## ADDENDUM NO. 2

Request for Proposal Call No. RFP2024-418  
**CONSTRUCTION OF THE FIELD HOCKEY & MULTISPORT TRAINING DOME,  
COMFORT STATION AT THE CASSIE CAMPBELL COMMUNITY CENTRE**

This Addendum forms part of the Bid/Proposal Document.

BOX CULVERT DETAIL WITH RISER - TYP

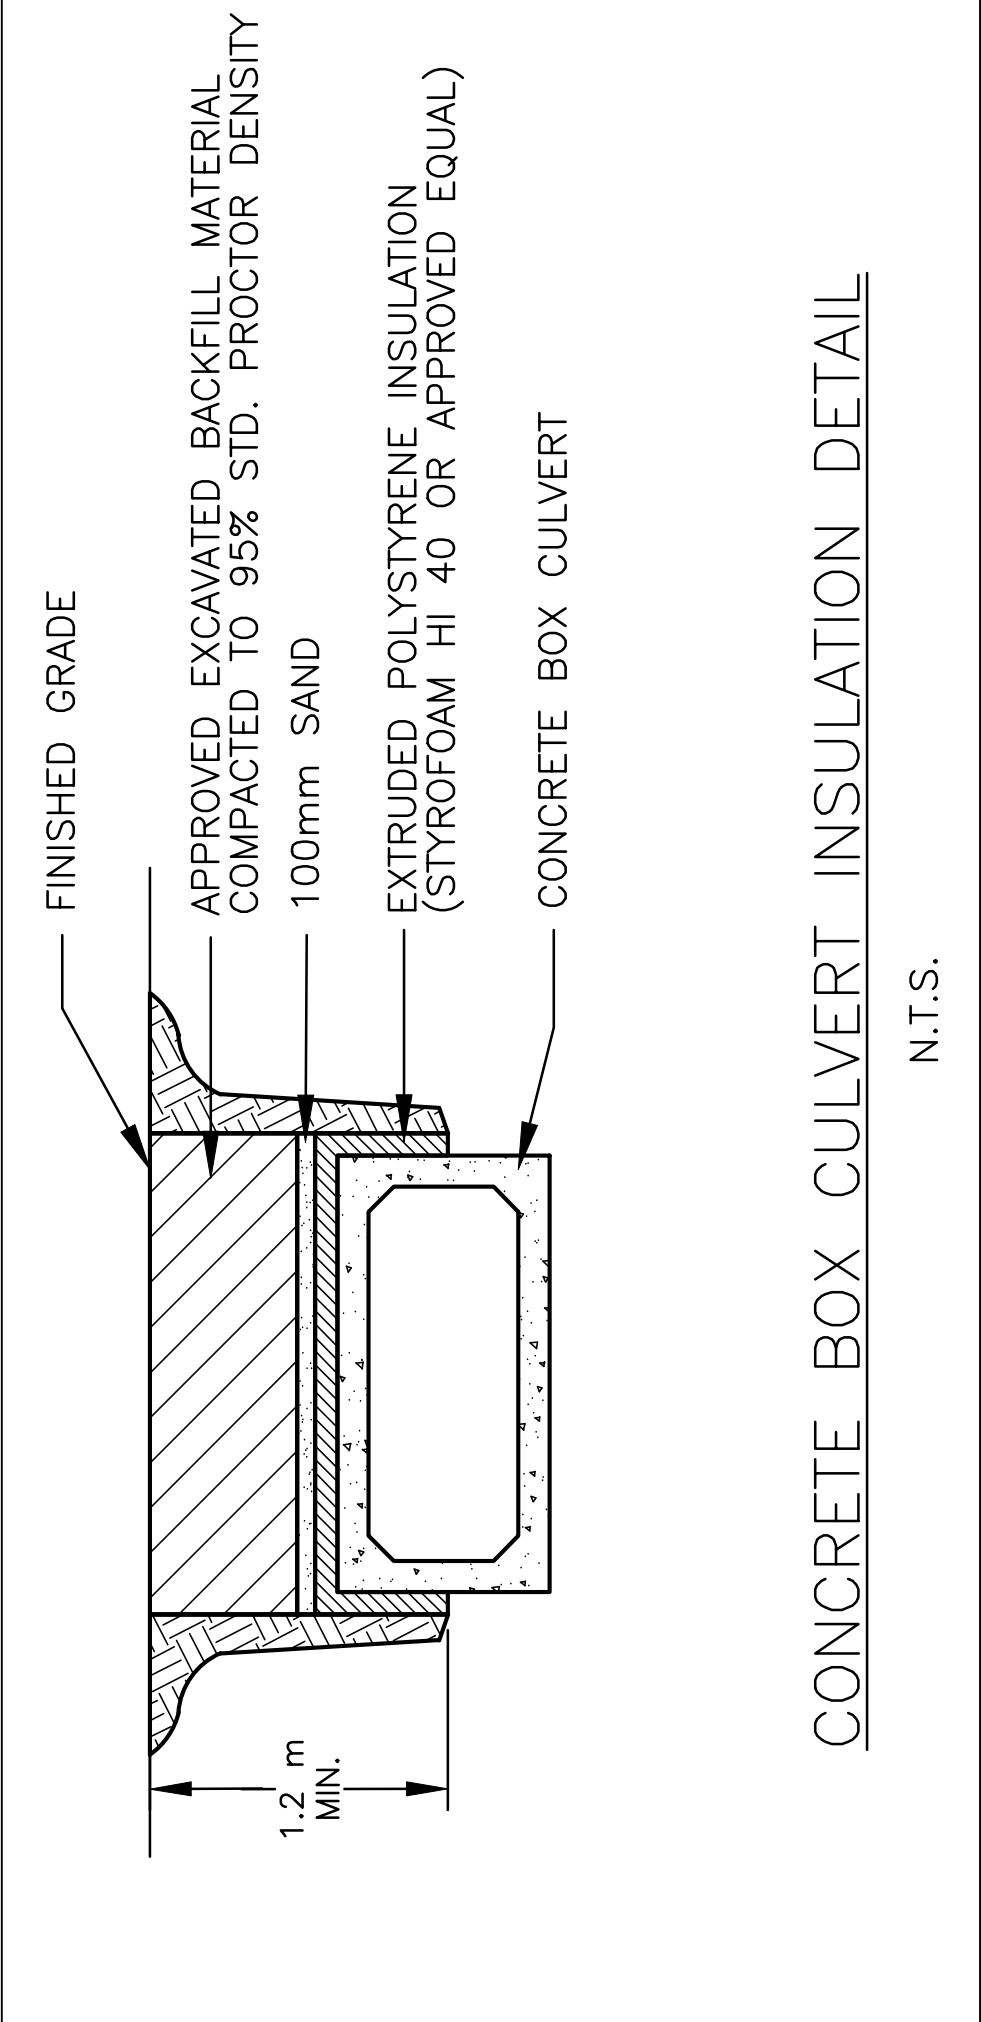
**Q8: Please provide insulation detail for the concrete box culvert storage tanks**

A8: Refer to attached concrete box culvert insulation detail titled, Response to question 8. ***(Total sheet of Drawing 1)***

drawing title  
**LANDSCAPE / SURFACE MATERIALS PLAN**

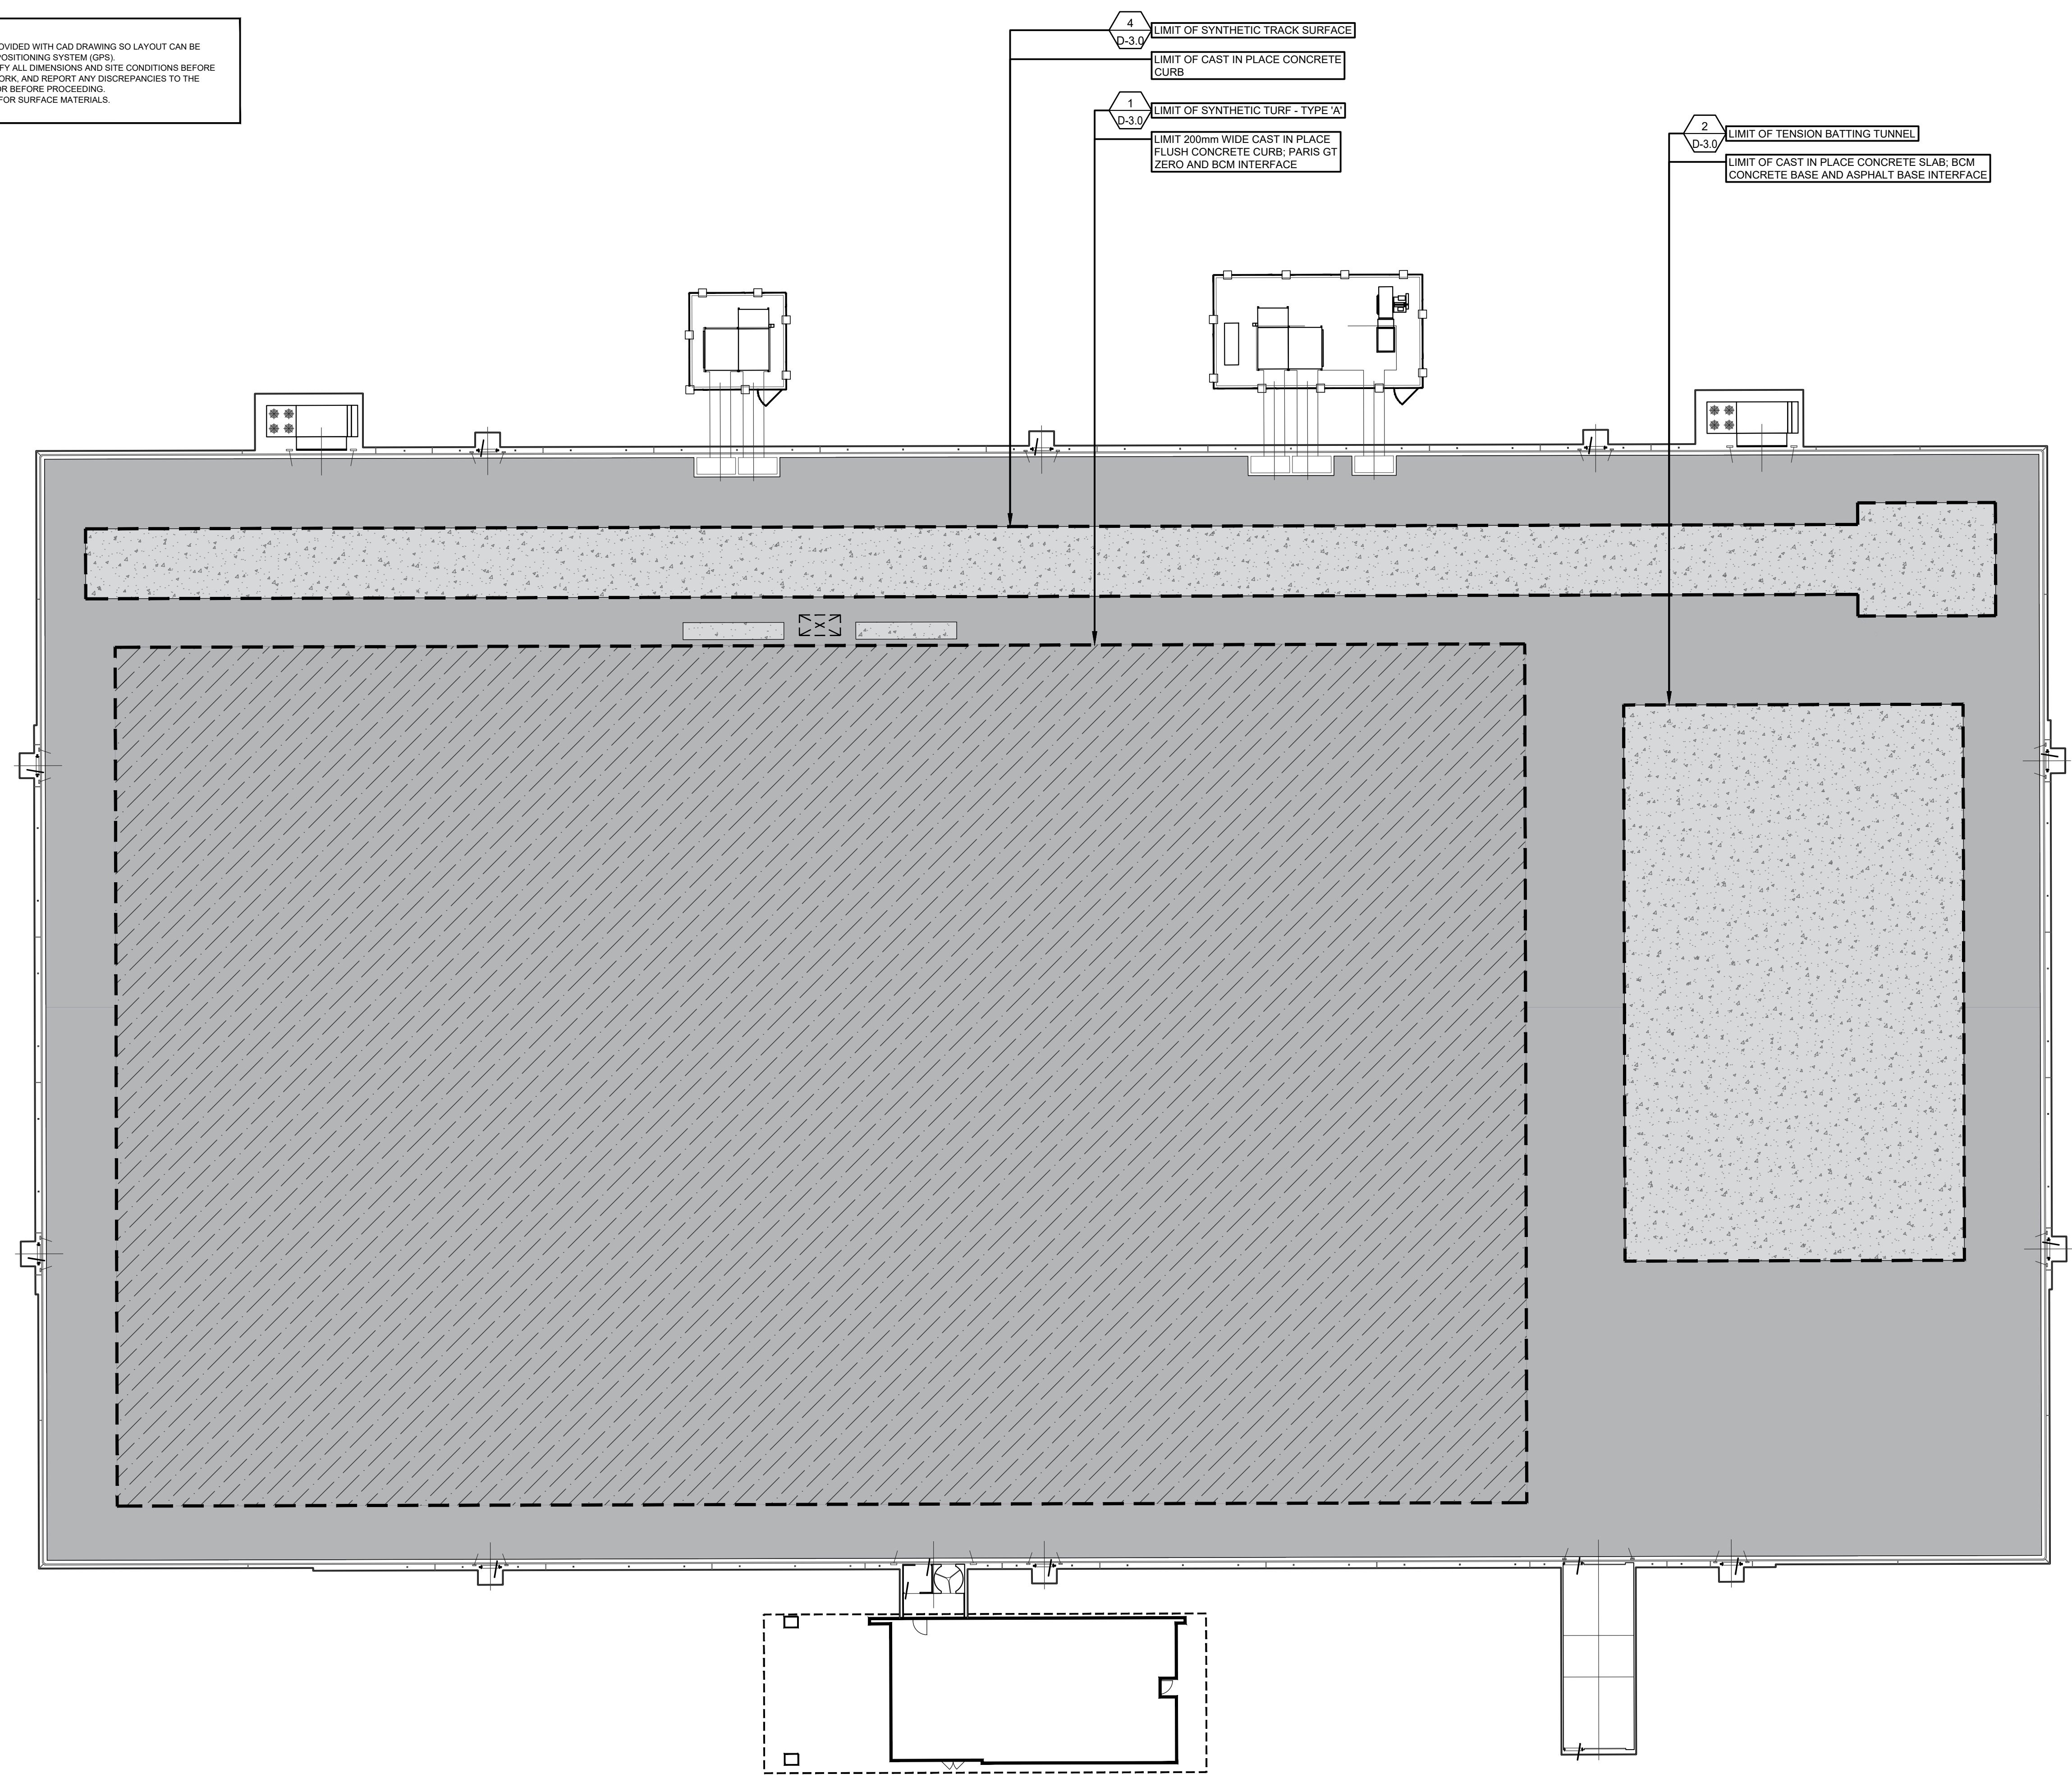
**Q24: Detail 2, D3.0 shows BCM turf adjacent to the grade beam. We don't see BCM turf adjacent to the GB in drawing L-1.0. Please clarify the detail and plan view drawing.**

A24: Refer to revised drawing L-1.0: Landscape/Surface Materials Plan.
